[Docket No. FAA-2011-0994; Directorate Identifier 2010-NM-143-AD]

**Airworthiness Directives; Bombardier, Inc. Model CL-600-2C10 (Regional Jet Series 700, 701, & 702), CL-600-2D15 (Regional Jet Series 705), and CL-600-2D24 (Regional Jet Series 900) Airplanes****AGENCY:** Federal Aviation Administration (FAA), DOT.**ACTION:** Notice of proposed rulemaking (NPRM).

2. The FAA amends § 39.13 by removing Amendment 39-14676 (71 FR 38979, July 11, 2006) and adding the following new AD:

**Figure 1**  
LH side shown  
RH side opposite

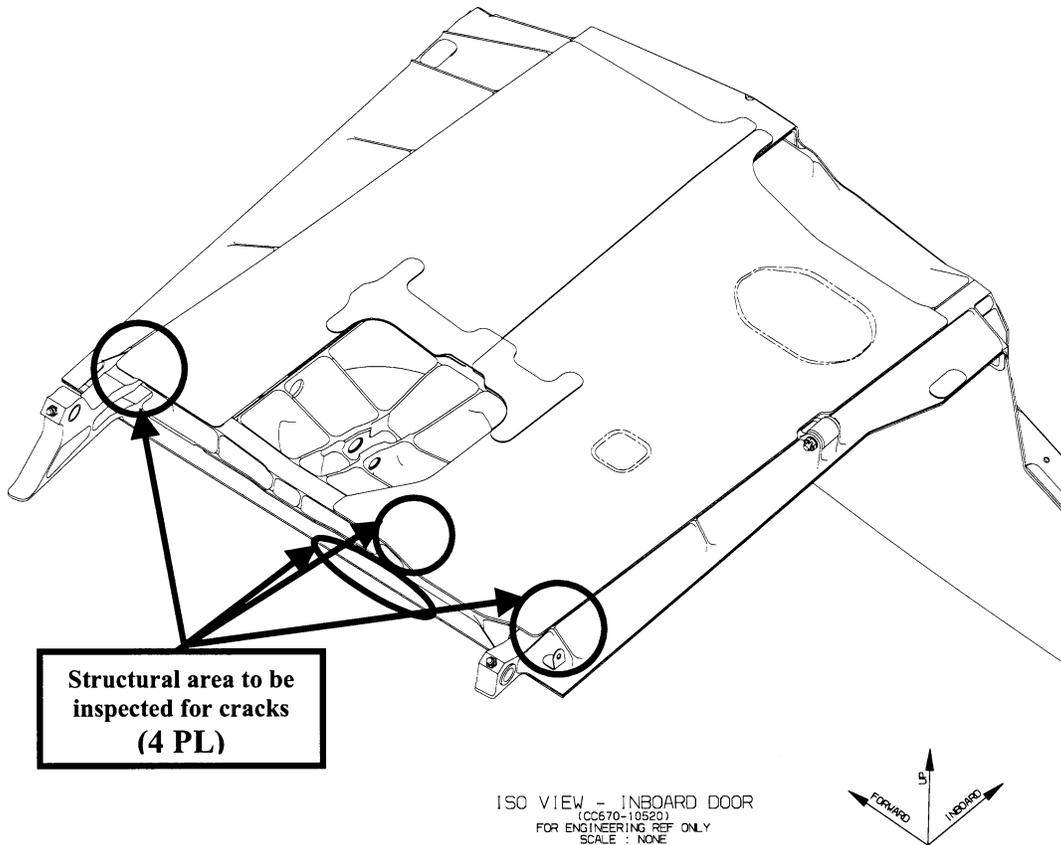
(h) For Model CL-600-2C10 (Regional Jet series 700 & 701) series airplanes, S/Ns 10003 through 10230 inclusive; and Model CL-600-2D24 (Regional Jet series 900) series airplanes, S/Ns 15002 through 15053 inclusive, 15055 and 15056: At the applicable time specified in paragraph (g) of this AD, perform detailed inspections of the lower panel, part number (P/N) CC670-10520, of the left- and right-hand MLG doors for the conditions and in the areas specified in paragraphs (h)(1), (h)(2), (h)(3), and (h)(4) of this AD; and Figures 1, 2, and 3 of this AD.

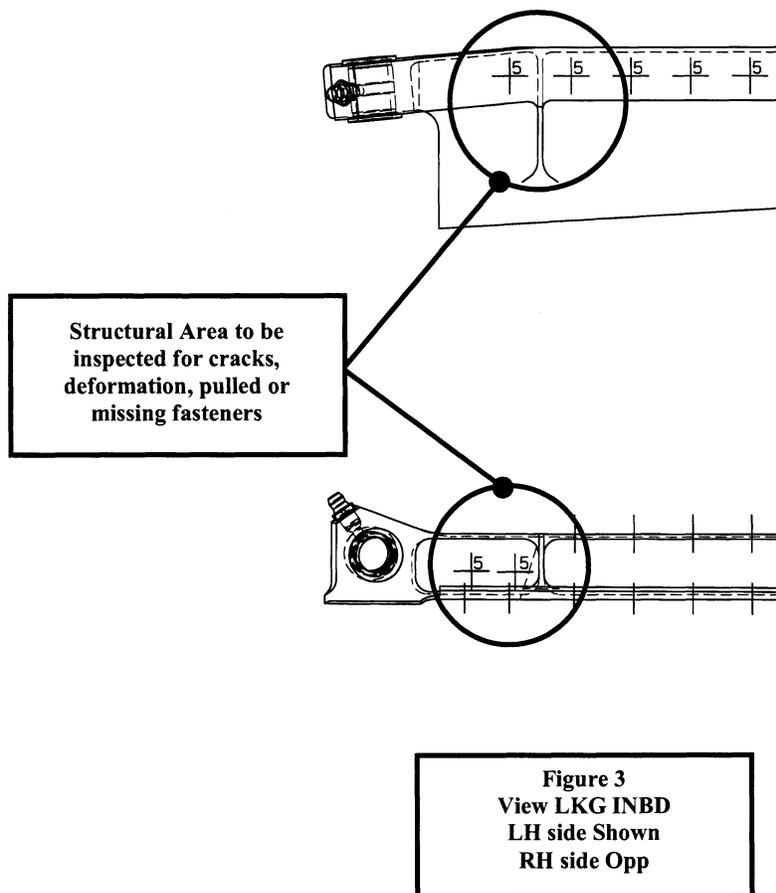
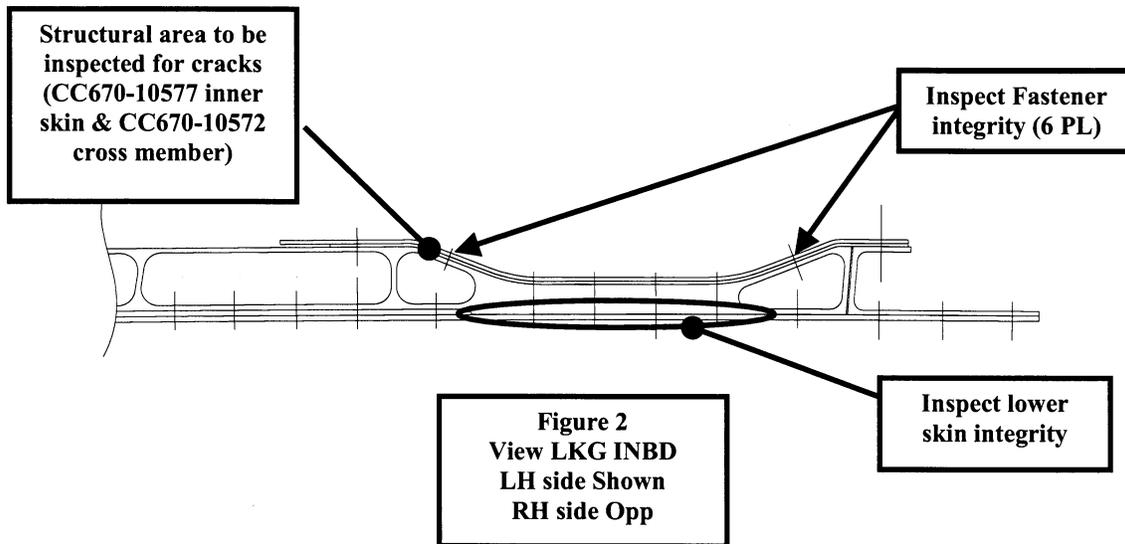
(1) Inspect the cross member, P/N CC670-10572, of the MLG door lower panel for cracking or deformation, in accordance with Figure 2 of this AD.

(2) Inspect the inner skin, P/N CC670-10577, of the MLG door lower panel at the cross member (P/N CC670-10572) for cracking or deformation, or pulled or missing fasteners, in accordance with Figure 2 of this AD.

(3) Inspect the outer skin, P/N CC670-10574, of the MLG door lower panel at the cross member (P/N CC670-10572) for cracking or deformation, or pulled or missing fasteners, in accordance with Figure 2 of this AD.

(4) Inspect the forward member, P/N CC670-10570, and aft member, P/N CC670-10571, of the MLG door lower panel for cracking or deformation, or pulled or missing fasteners, in accordance with Figure 3 of this AD. Figures 1 through 3 of this AD follow.
